Construction Division
Additions & Alteration Charges Approval Form

ESTIMATE SHEET

Quality Control Check Report.

Quality Control Check Report, Stage: After Plastering (Apartments)

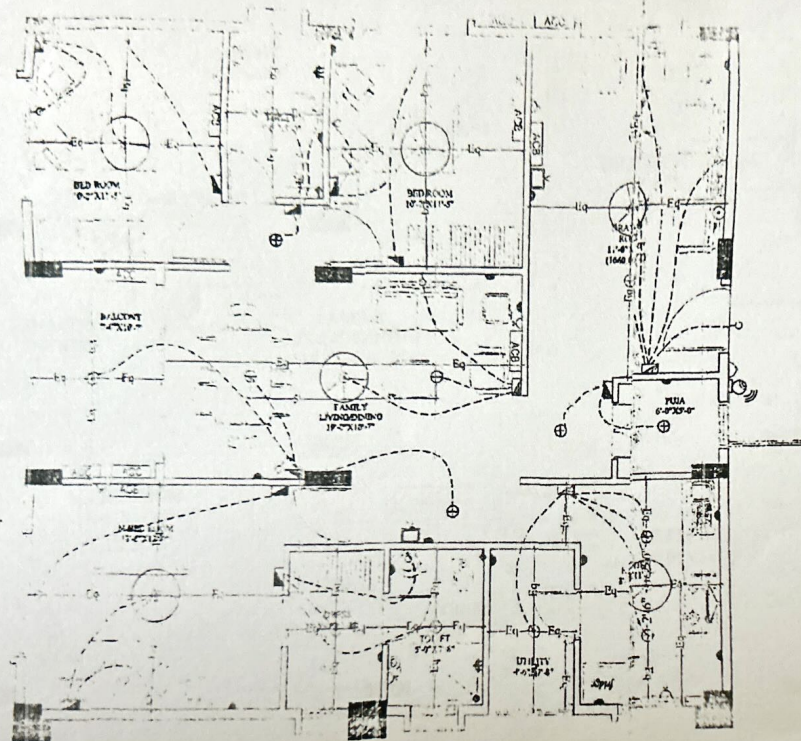
① Giova Holes were not packed in the flat 2) As per customer's request changes were done in the flat. ③ In Kitchen couple of electrical points were not

Signed by engineer,	☒ Yes ☐ No	Signed by customer,	☒ Yes ☐ No
Revised drawing required from HO	☐ Yes ☐ No	Approved revised drawing attached	☐ Yes ☐ No

Screeding done on walls upto 12" outside bathroom/utility	☒ Yes ☐ No
Bathroom /utility filled with 4" water for water proof check	☐ Yes ☒ No
Hole packing done around all pipes in ceiling and internal walls	☐ Yes ☒ No
Remarks: ① In M-Toi ledge wall work was pending.
